CCEA MOBA

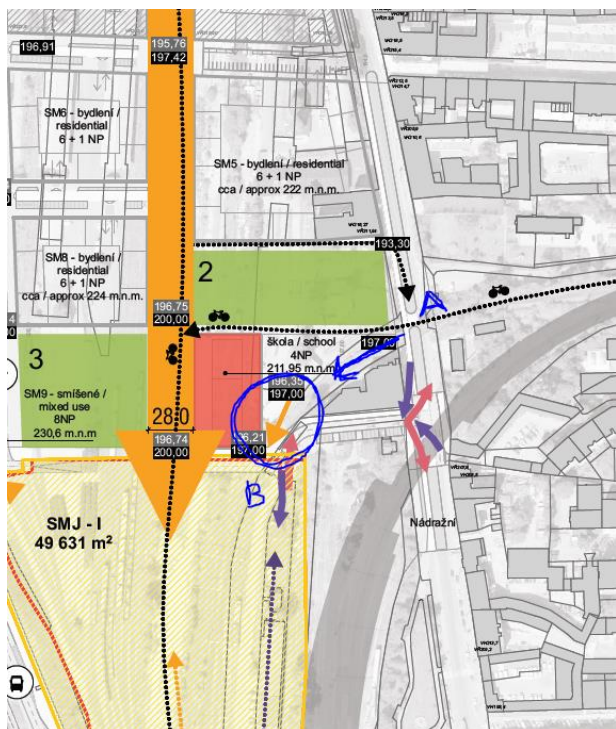
19 / Co znamená oranžová šipka? Viz příložený obrázek.

Oranžová šipka indikuje tok chodců do Smíchov City Jih; tedy chodník podél ulice vedoucí ke škole a vstup do jižní části území.

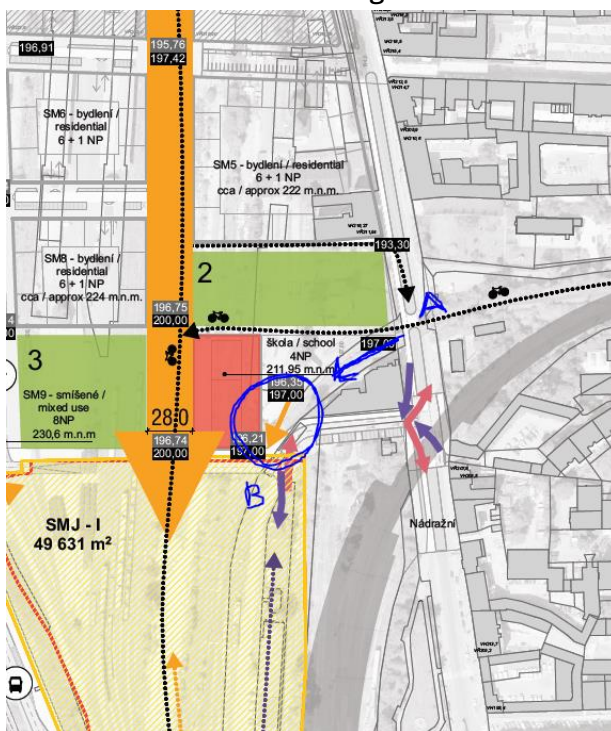
19 / there is an orange arrow indicating pedestrian entry to the SMC area on the south east edge of the site. Does it mean there will be a public passage through the site following the line of the railway tracks - leading people from the viaduct to the end of the arrow (from A to B)? Please see the attached image.

The orange arrow indicates a pedestrian flow to the South of the Smíchov City, meaning a sidewalk/pavement along the street leading towards the school and access to the southern part of the whole area.
